Access Compliance Report
Public Rights-of-Way
(Curb Ramps)

Intersection ID: 54709	**Main Street: MARY_BUTLER_WY**	**Cross Street: OLD_PROVIDENCE_RD**	**Location: SW**
ADA ID: 6CB6EB725D68	**Ramp Type: Perp**	**Initial Pass/Fail: Fail**	**Overall Compliance: No** / **Severity Score: 12.5**

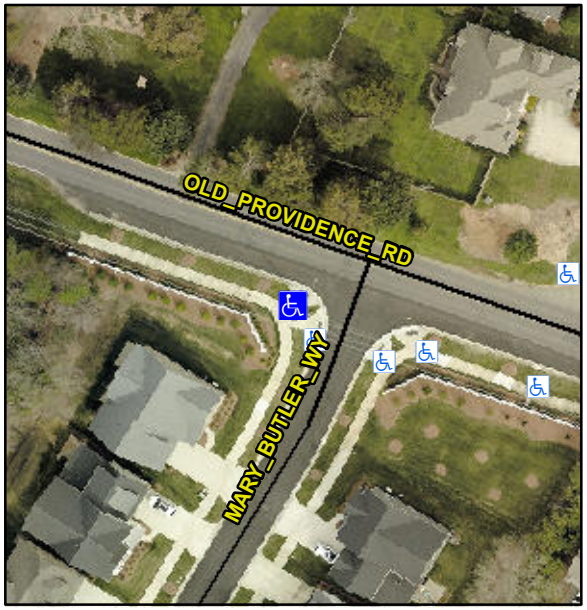
Not Found, R304.5.3

Compliance	Description	Data	Compliance	Description	Data
N/A	Ramp Length (in)	96.0	Yes	Ramp Slope (%)	5.8
Yes	Ramp Width (in)	72.0	No	Ramp XSlope (%)	5.4
N/A	Flare Type LT	N/A	N/A	Flare Type RT	N/A
N/A	Flare Slope LT (%)	N/A	N/A	Flare Slope RT (%)	N/A
N/A	Flare Traversable LT?	N/A	N/A	Flare Traversable RT?	N/A
N/A	Landing Length (in)	N/A	N/A	DWS Provided?	N/A
N/A	Landing Width (in)	N/A	N/A	DWS Contrast?	N/A
N/A	Landing Slope (%)	N/A	N/A	DWS Length (in)	N/A
N/A	Landing X Slope (%)	N/A	N/A	DWS Full Width?	N/A
N/A	Landing Curb? (Y/N)	N/A	N/A	DWS Offset (in)	N/A
N/A	Shared Landing?	N/A			
N/A	Gutter Ponding?	N/A	N/A	Gutter Slope (%)	N/A
N/A	Gutter Lip Ht (in)	N/A	N/A	Gutter X Slope (%)	N/A
N/A	Painted X Walk1?	No	N/A	Painted X Walk2?	N/A
	X Walk 1 Direction	To NE		X Walk 2 Direction	N/A
N/A	X Walk 1 Width (in)	N/A	N/A	X Walk 2 Width (in)	N/A
	X Walk 1 Slope (%)	1.5		X Walk 2 Slope (%)	N/A
	X Walk 1 X Slope (%)	3.3		X Walk 2 X Slope (%)	N/A

Remove & Replace Entire Ramp.
